CONSUMERS POWER COMPANY  
DOCKET NO. 50-155  
BIG ROCK POINT NUCLEAR PLANT  
AMENDMENT TO OPERATING LICENSE

Amendment No. 17  
License No. DPR-6

ATTACHMENT TO LICENSE AMENDMENT NO. 17

FIGURE 6.2-1

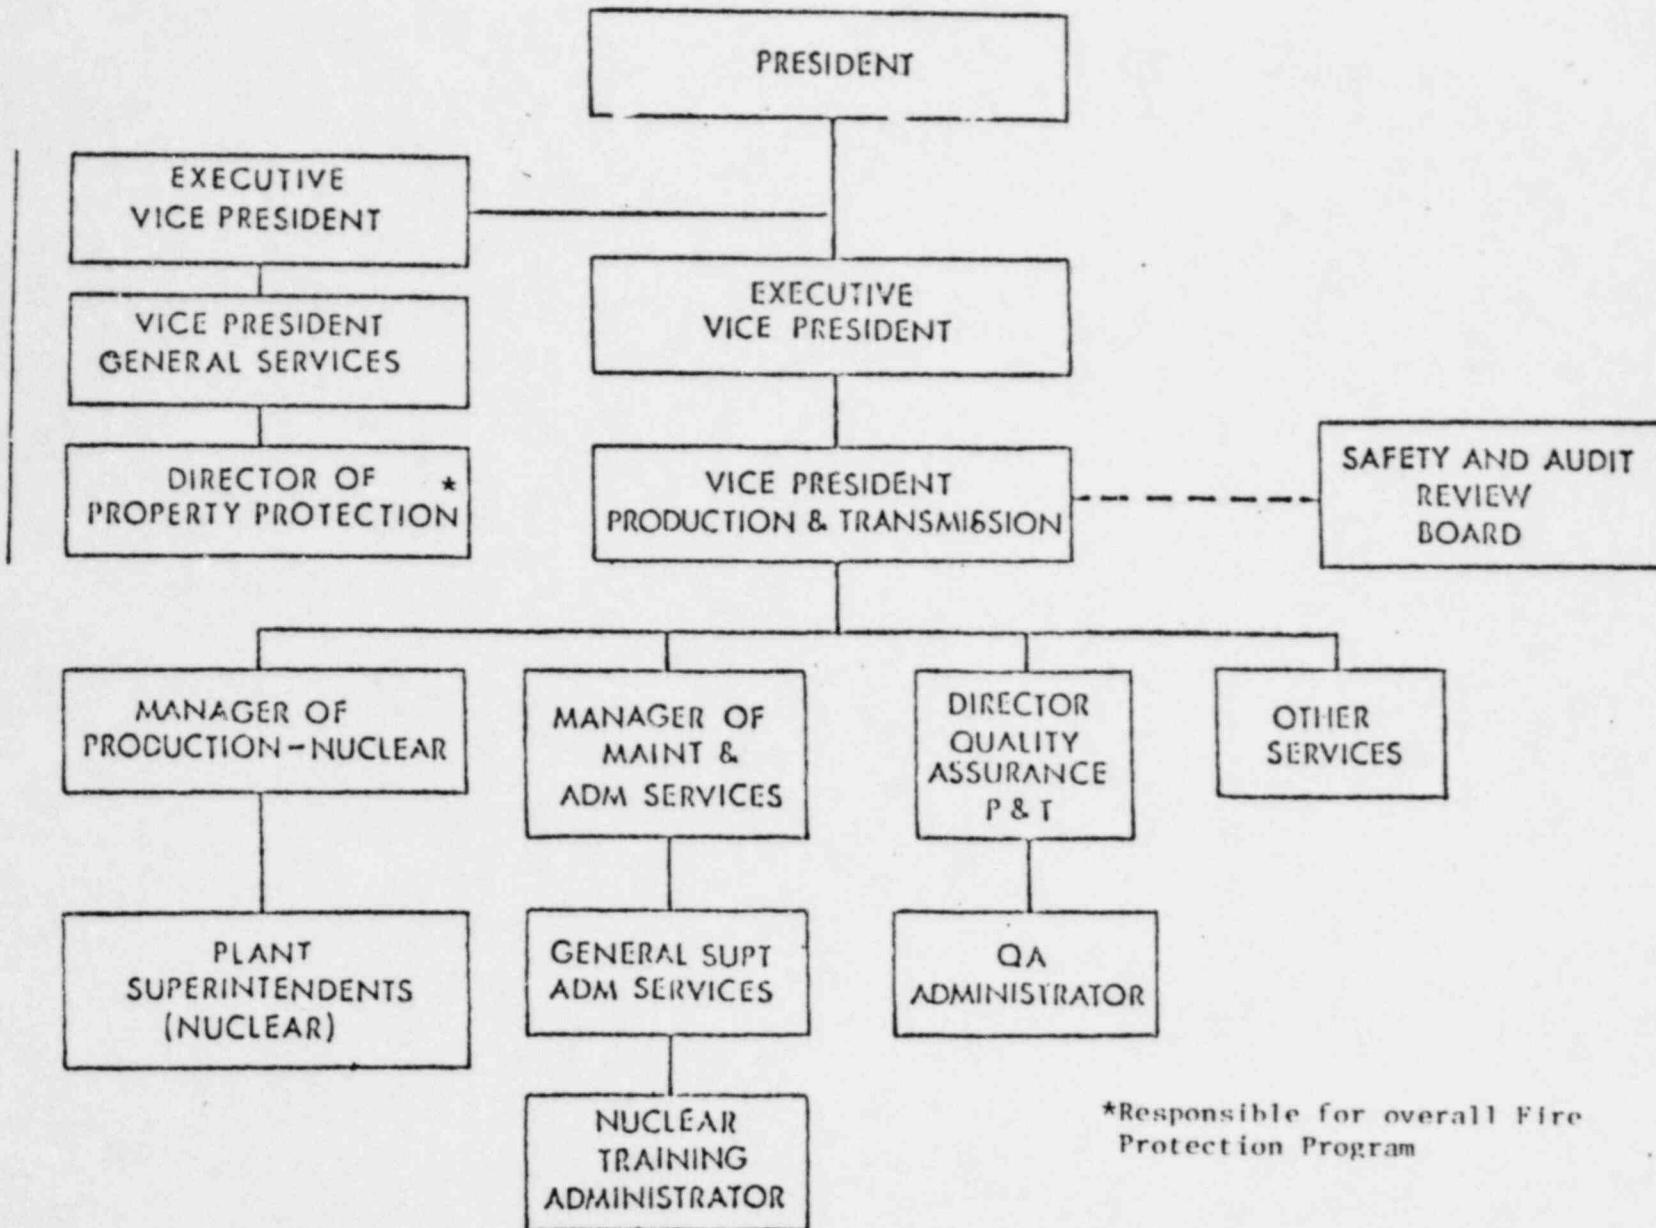
iv  
10-1  
10-2 (Figure 6.2-1)  
10-3 (Figure 6.2-2)  
10-5  
10-10  
10-20  
-  
-  
-  
-  
-  
-  
-  
-

iv  
10-1  
10-2 (Figure 6.2-1)  
10-3 (Figure 6.2-2)  
10-5  
10-10  
10-20  
12-1 (new)  
12-2 (new)  
12-3 (new)  
12-4 (new)  
12-5 (new)  
12-6 (new)  
12-7 (new)  
12-8 (new)

6.2.1 The offsite organization for plant management and technical support shall be as shown on Figure 6.2-1.
